E5071A-03

S E R V I C E N O T E

E5071A ENA Series Network Analyzer, 300 kHz to 8.5 GHz

Handler I/O Port Malfunction Due to TTL-Low Level Threshold Voltage Anomaly

Figure 1. Threshold voltage anomaly

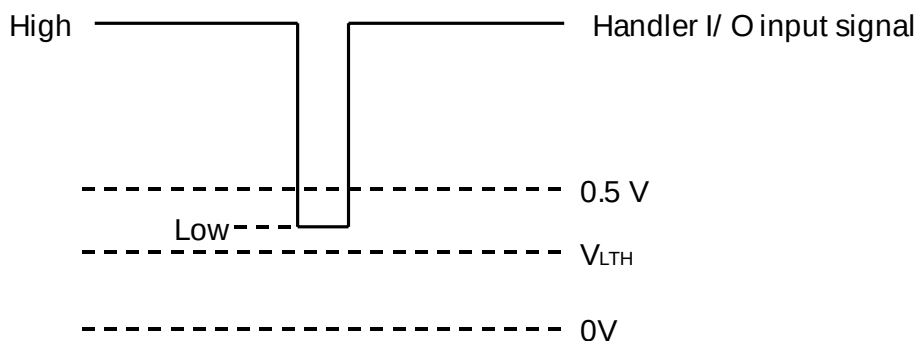
The 24-bit handler I/O of the E5071A units with the specified serial numbers may not function normally. Due to the possible threshold-voltage anomaly of TTL input circuit at either of the I/O pins 2, 18 and 22 through 29, the handler I/O port may ignore the “Low” state of control input signals. When the threshold voltage for TTL-Low level is too low (lower than 0.5 V), it is possible that control input signal does not cross the threshold voltage (V_{LTH}) though the “Low” level of the signal is within the recommended voltage range (0 V to 0.5 V). As a result, a handler interface error occurs. See Figure 1.

When the threshold voltage of the handler I/O (either of the I/O pins) is too low, replace the A23 Handler I/O board with new one (P/N E5070-61006).
